# ARTICLE INFORMATION ON OVERRUNNING ALTERNATOR PULLEY 55627

TECHNICAL INFO NO. 1005

Dacia, Renault

RUVILLE ref.	OE ref.	Generator ref.
55627	77 00 110 616 (replaced)	82 00 323 137
	77 01 477 689 (current)

Fig. 1: Alternator Belt Pulley 77 00 110 616

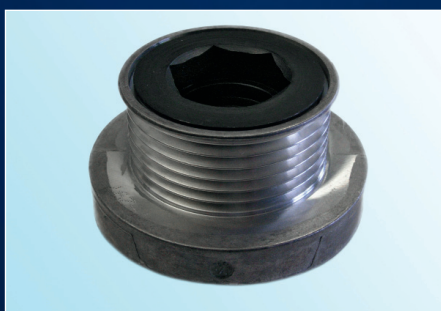
Should the alternator belt pulley be defective (OE ref. 77 00 110 616), it is to be replaced by an overrunning alternator pulley. The overrunning alternator pulley is available with RUVILLE No. 55627.

Fig. 3: Replacement procedure

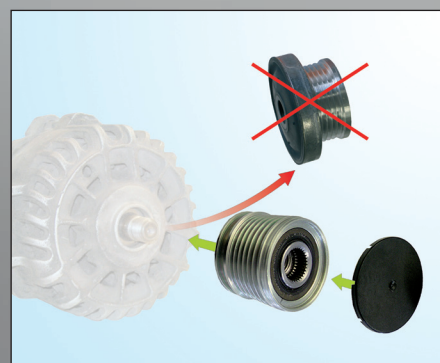
1. Slacken tensioner and remove poly V-Belt
2. Check all belt drive components for damage  
- replace damaged components
3. Remove the original belt pulley from the alternator (see Fig. 3)
4. Assemble the Overrunning Alternator 55627 with the relevant special tool.
5. Assemble the seal cap on the Overrunning Alternator Pulley  
- Ensuring it is seated correctly and is a tight fit!
6. Assemble the poly V-Belt
